Canton Police Station Reno
Project No.: 2023-001-01
Issue to: Bidders

Town of Canton, Owner
Contract Document Date: July 07, 2025
Addendum Date: March 31, 2026

END OF ADDENDUM 1

FINISH PLANS

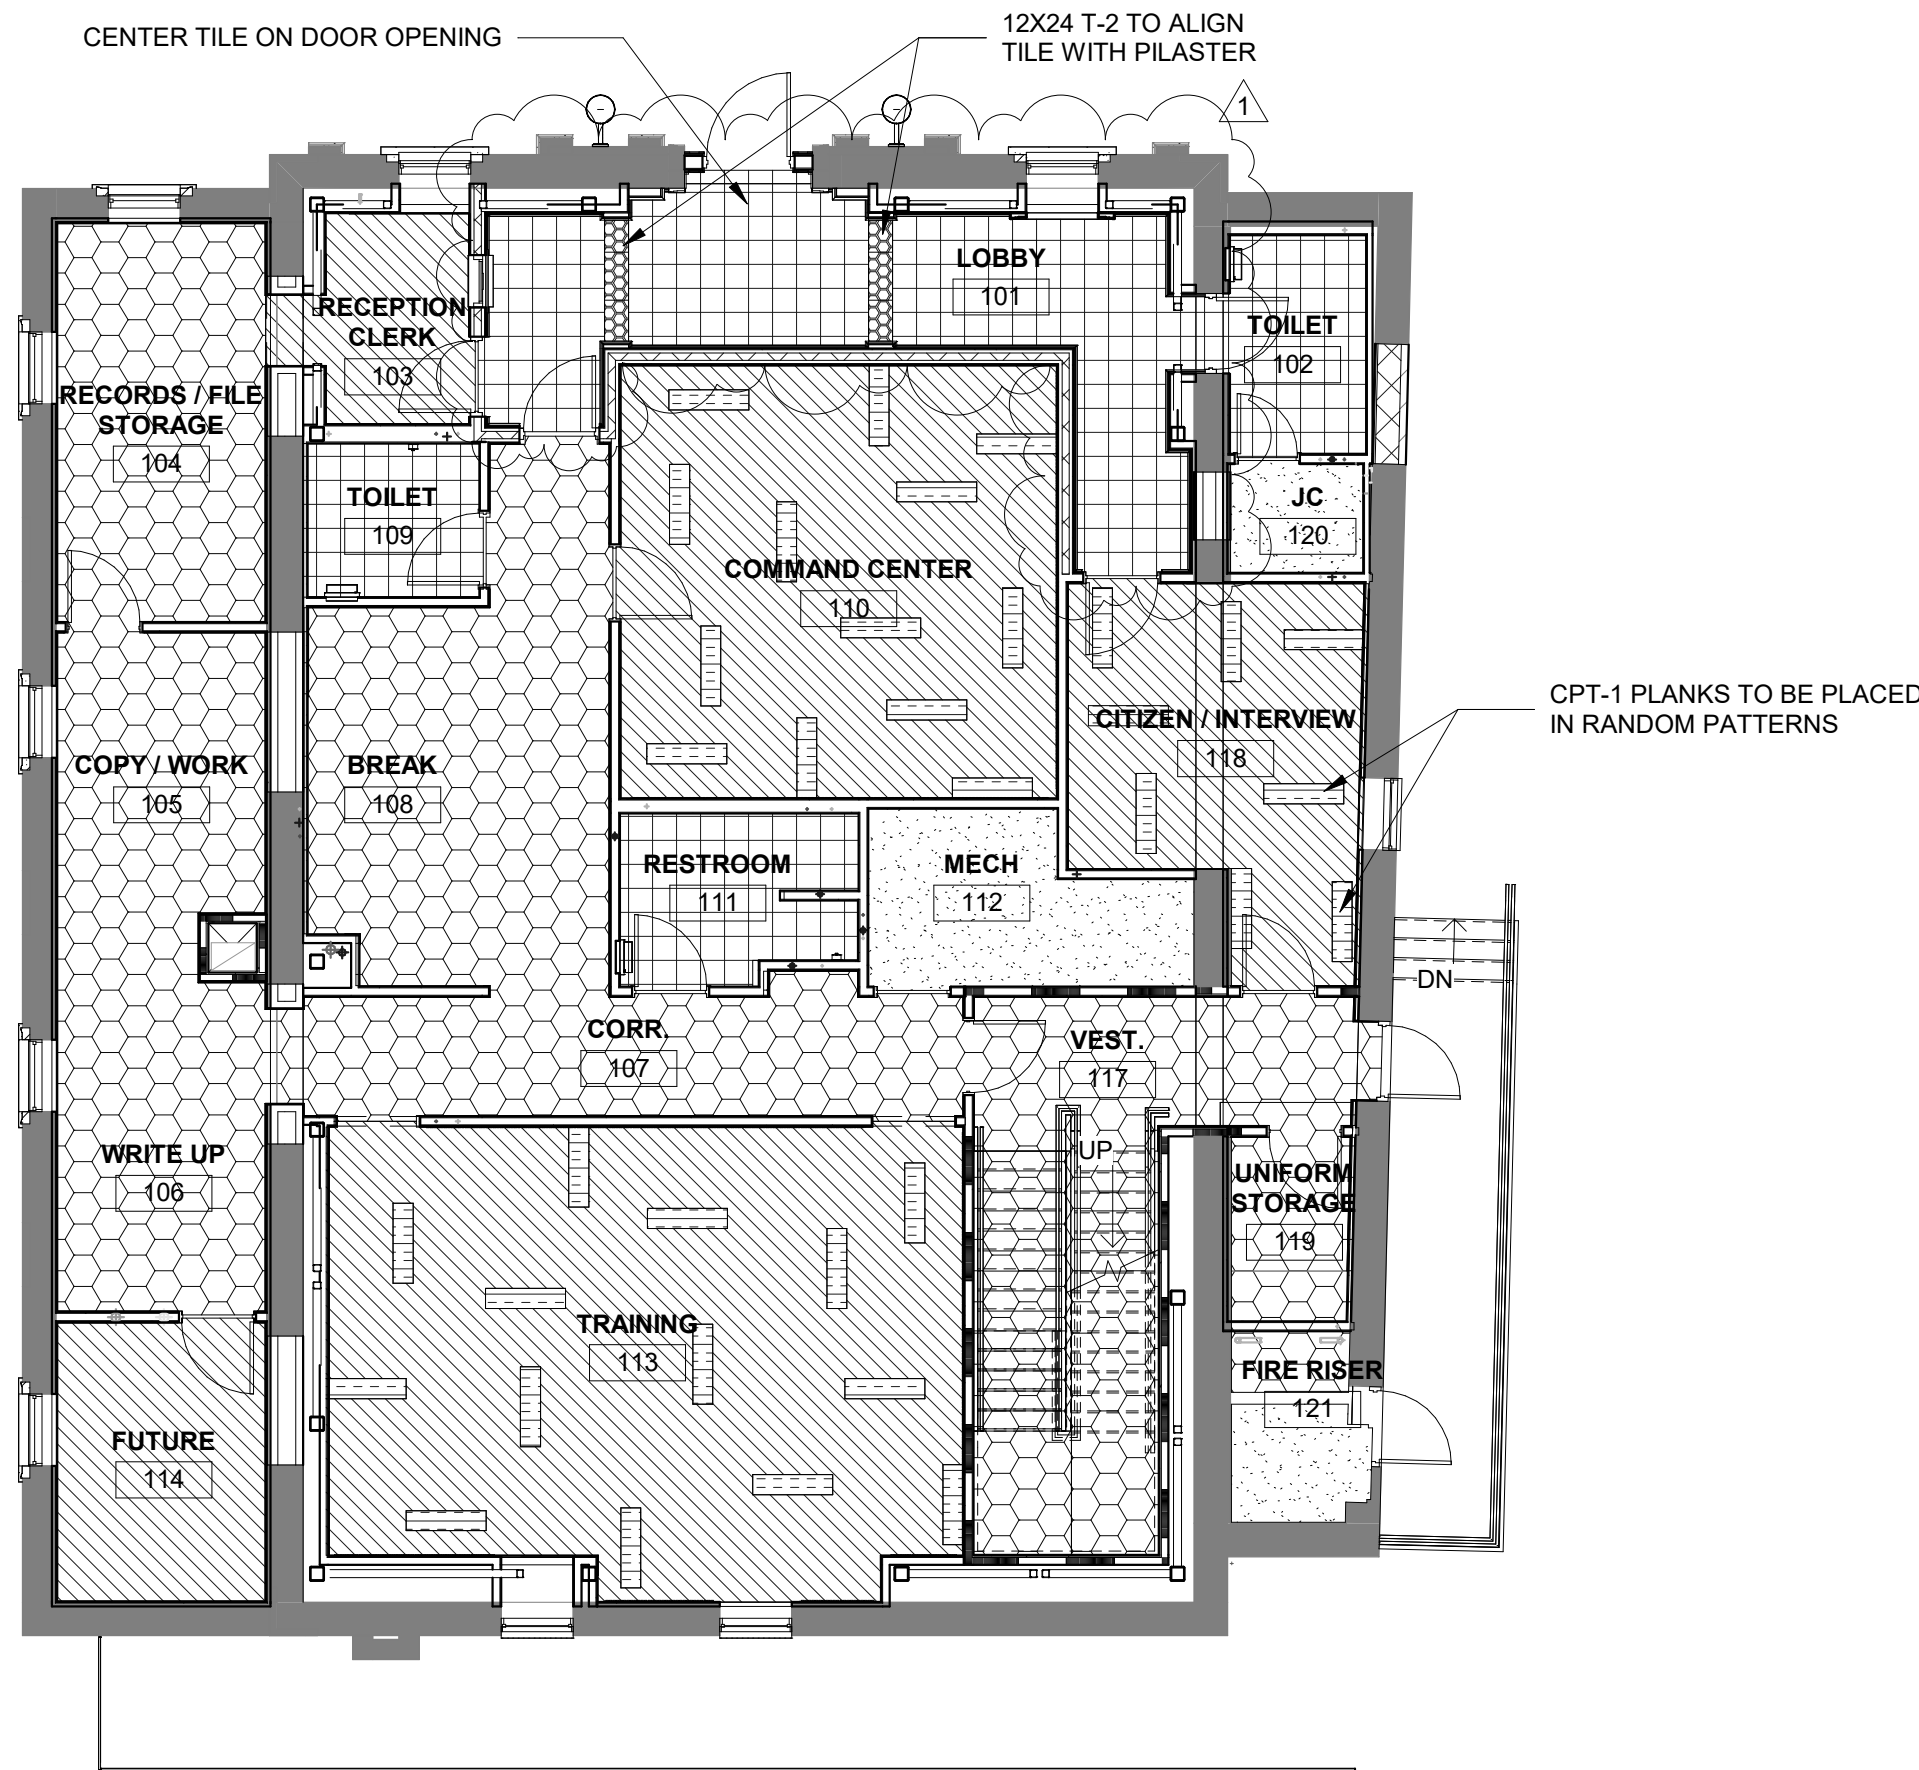
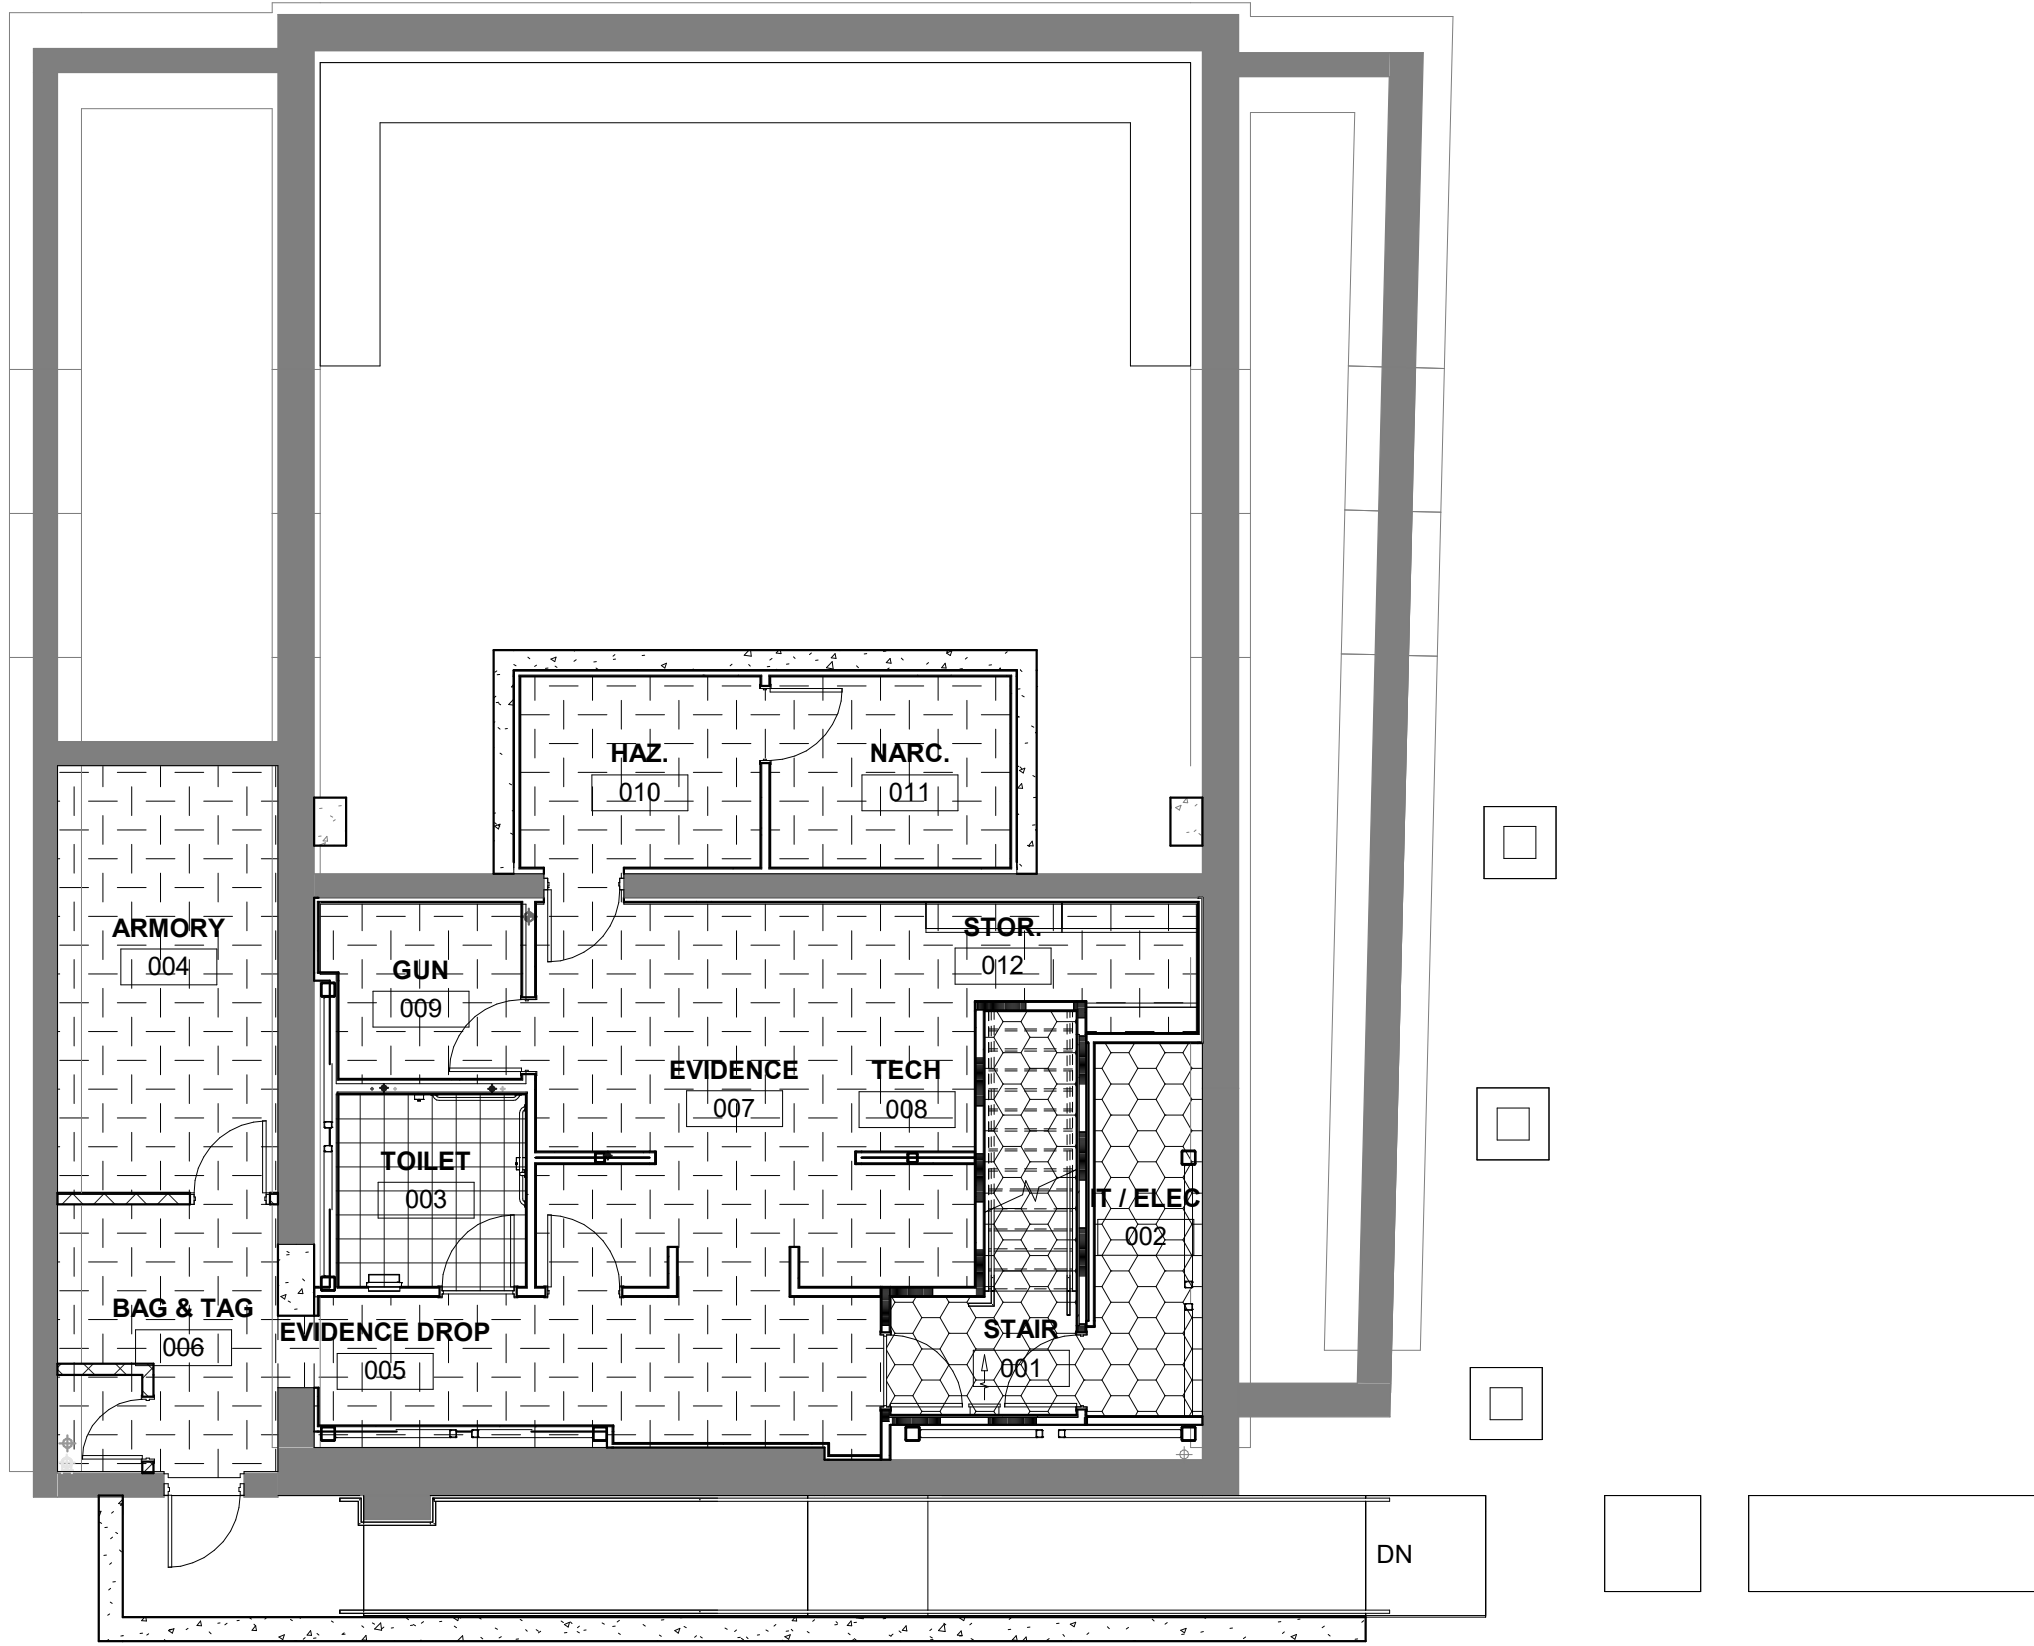
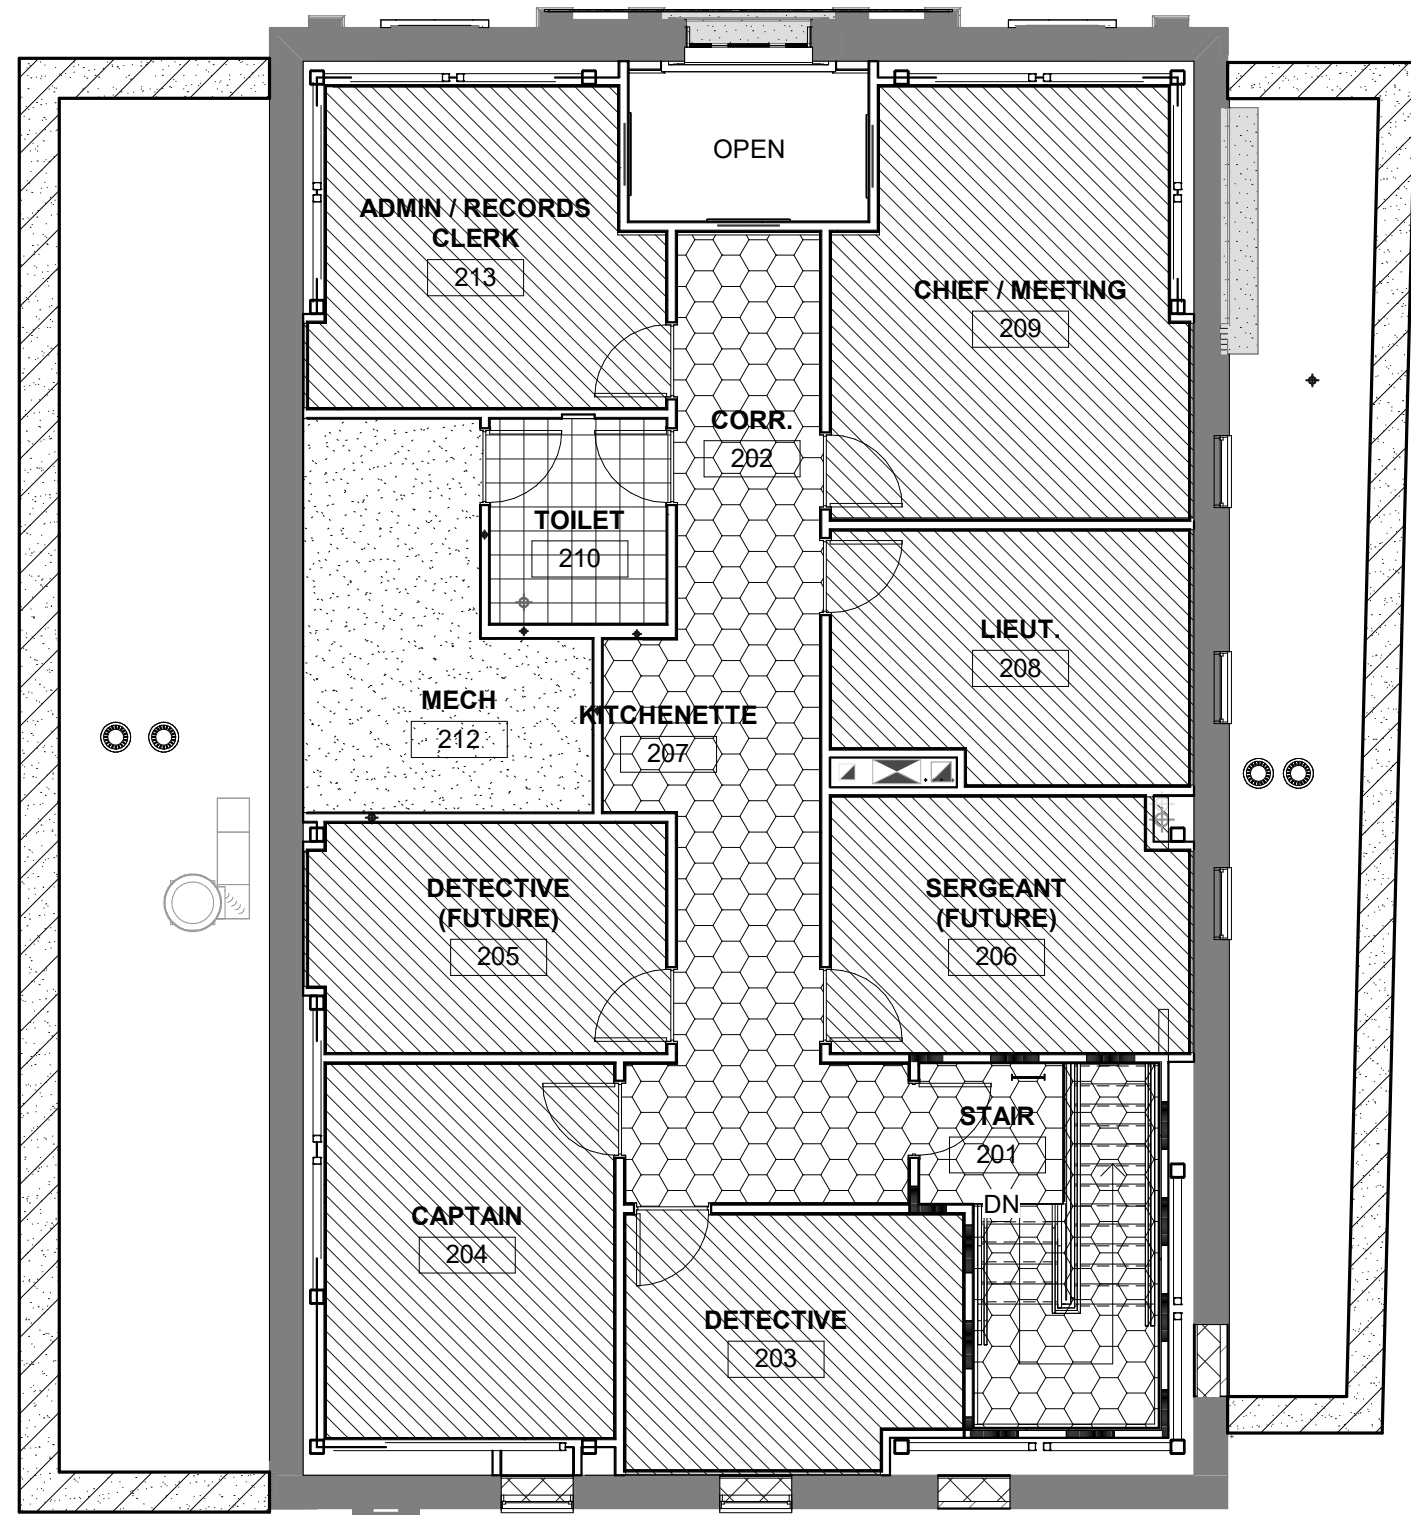
- e) T-5: Please confirm if Matte is the desired finish as K189 is gloss, The matte would be K-789.
 - 1) Use K-789. Drawings revised.
- f) The T-1 and T-2 tiles are shown with two T-1 12"x12" tiles aligning with the 24" side of the T-2 tiles. The two 12"x12" tile without a grout line will overhang the 24" side by 3/16". Please advise if there will be a design change.

- 1) Sheet A10.21 has been revised to separate the grout lines to avoid this issue. Also, T-2 has been removed in the main field of tile and only occurs at the pilaster threshold.
